THM 440-T4
NEW DRIVEN SPROCKET SUPPORT AND CHAIN SCOOP

CHANGE: A new Driven Sprocket Support and Chain Scoop is now used in production on all 1990 vehicles equipped with a THM 440-T4 (4T60) transaxle. (See Figure 1).

Figure 1

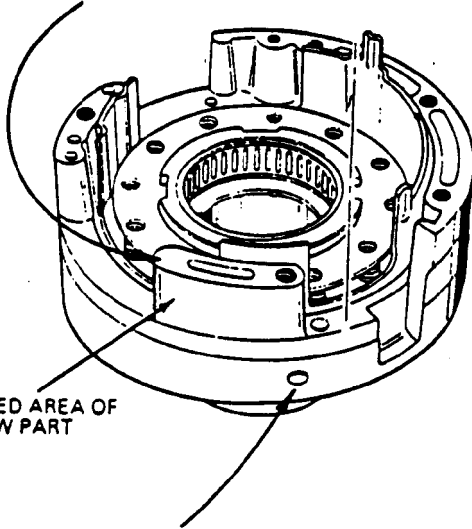
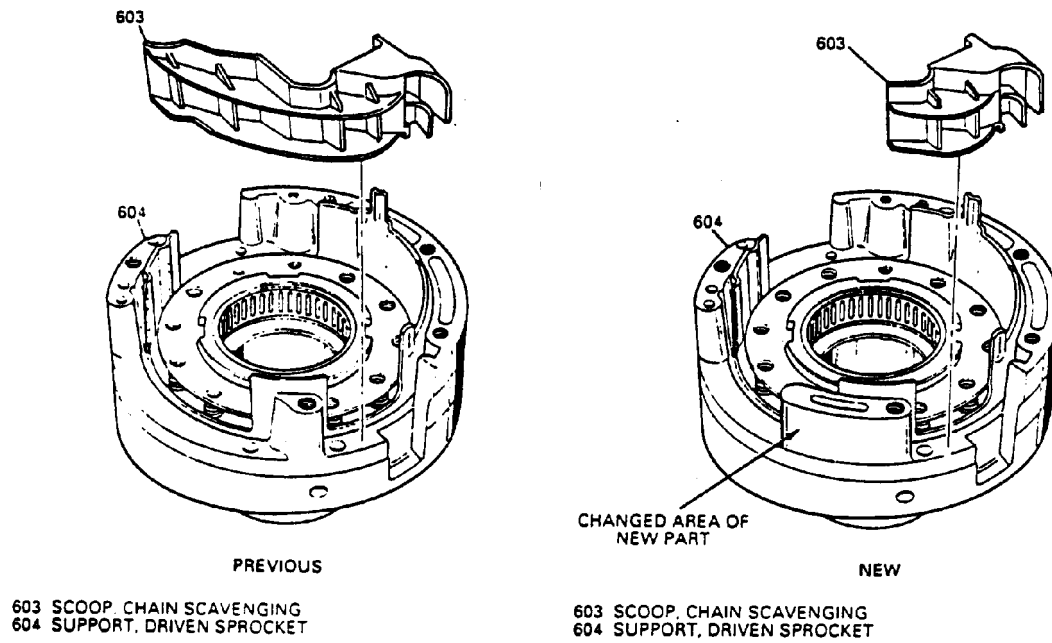
(1) DRIVEN SPROCKET SUPPORT - The new design sprocket support has an increased width of one leg on the support (See Figure 1). The wider leg on the new support will accommodate a new lube feed passage for the new THM F-31 (4T60-E) transaxle. Lube feed for the THM F-31 (4T60-E) will be thru the channel plate, instead of the pipe from the accumulator cover as on the THM 440-T4 (4T60) (See Figure 2).

(2) CHAIN SCOOP - The new sprocket support requires the chain scoop, both black and white, to be about l/3 the length of the previous chain scoop. (See Figure 1).

Figure 2

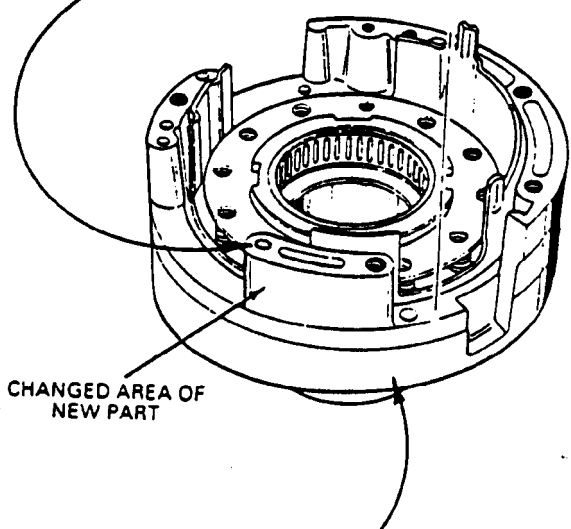
HOLE DRILLED HERE FOR LUBE FEED

HOLE DRILLED HERE TO ACCEPT LUBE PIPE
FROM THE ACCUMULATOR COVER

Figure

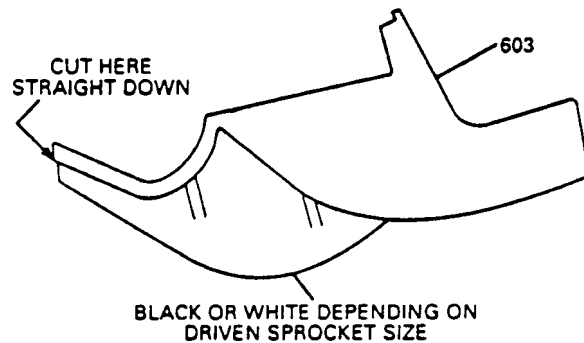
The new driven sprocket support will service all past models, but the new length (Short) chain scoop must be used with it. The previous (Long) chain scoop will not fit, but can be cut to fit the new support. Lay the previous chain scoop on the actual size drawing in Figure 3 and cut straight down, as indicated, with a hack saw. Smooth off the rough cut edge with sandpaper. The new length (Short) chain scoop must be used ONLY with the new design driven sprocket support.

CUT HERE
STRAIGHT DOWN
